Greenbelt Alliance
East Bay Field Office
1601 N Main St #105
Walnut Creek CA 94596

October 13, 2005

City of Oakley
Planning Division
3231 Main St.
Oakley, CA 94561

We have reviewed the Draft Environmental Impact Report¹ (“DEIR”) prepared for the City of Oakley’s (“City”) proposed East Cypress Corridor Specific Plan (“Specific Plan” or “Project”). We submit this letter to express our concern that the DEIR does not comply with the requirements of the California Environmental Quality Act (“CEQA”), Public Resources Code Section 21000 et seq., and the CEQA Guidelines, California Code of Regulations, title 14, Section 15000 et seq. (“CEQA Guidelines”). Additionally, the Specific Plan does not comport with State Planning and Zoning Law. Gov’t Code § 65000 et seq.

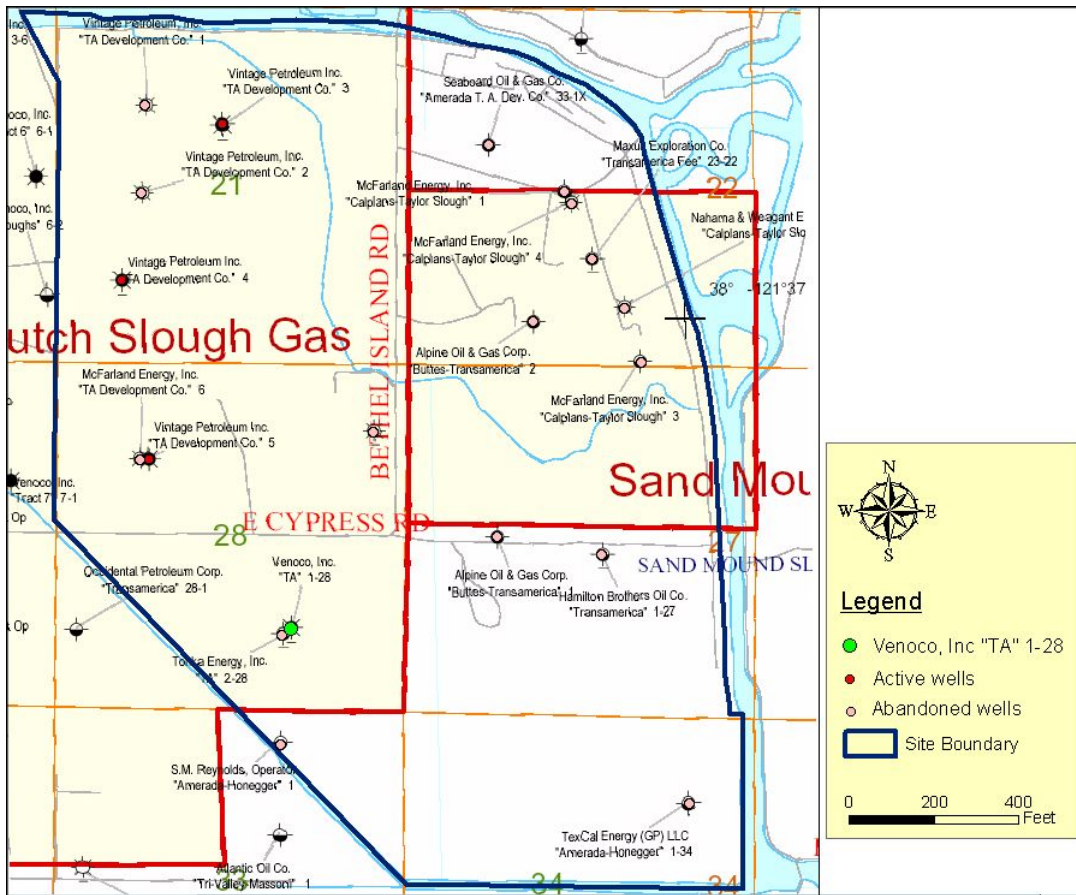
The Specific Plan states that the area proposed for development “contains seven active gas well sites” (p. 3.31). The number of active wells as stated in the Specific Plan is inconsistent with a hazardous waste report (attached as Appendix K to the Specific Plan) which concluded “at least four natural gas wells are located on the site” (p. 27).

To reconcile the inconsistent information in the two documents, we referenced a California Division of Geology and Geothermal Resources map that definitively identifies four active wells (<ftp://ftp.consrv.ca.gov/pub/oil/maps/dist6/608/Map608.pdf>). This map shows the inaccuracies in the Specific Plan.

A revised Specific Plan should positively identify and locate the number of active wells in the planning area. A revised Specific Plan should also be prepared to show the specific boundaries of the proposed buffers. Additionally, the Specific Plan should clarify what residential “screening” process will entail.

Figure 1: Scour holes in western Delta that resulted from historical levee breaches

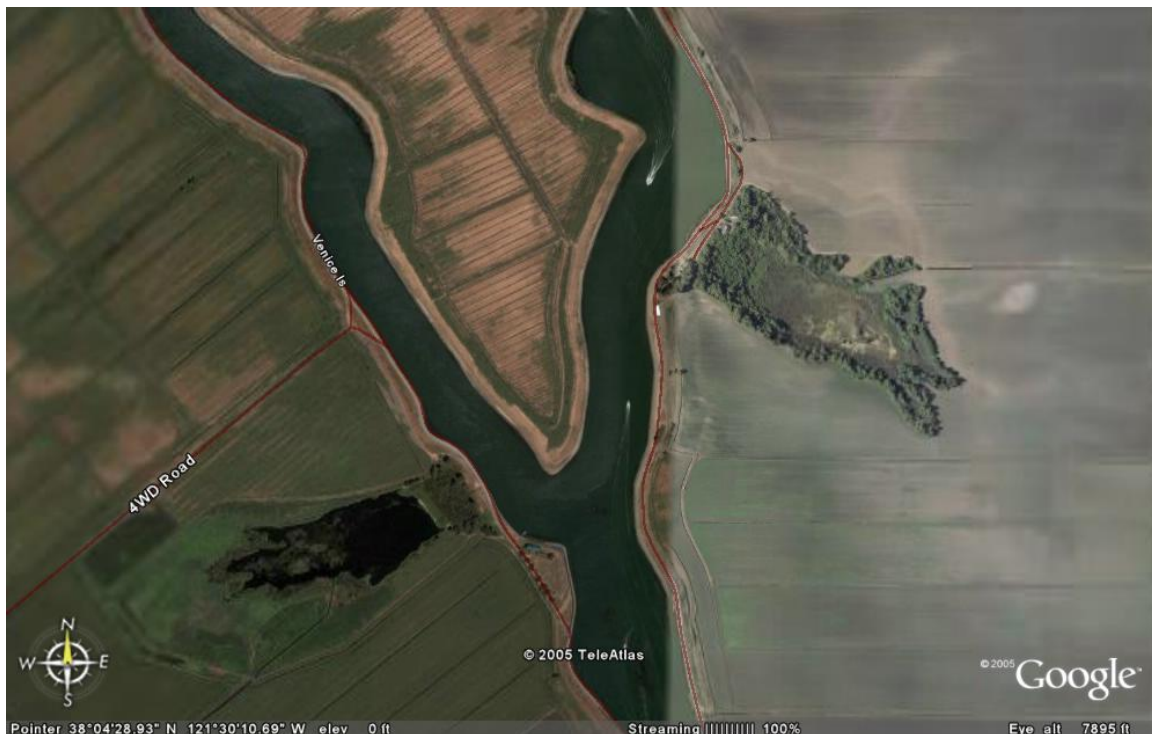
Greenbelt Alliance requested that the City analyze the potential for scour in the NOP comments, but the City and project proponents have apparently ignored this request and thereby failed to perform this essential analysis. Without this analysis, and a careful peer review, there is no way that decision makers can adequately assess the potential impacts of the project to public health and safety. The DEIR must be revised to analyze this issue utilizing a 3 dimensional hydraulic model and detail specific mitigation measures to reduce adverse impacts to a less than significant level.
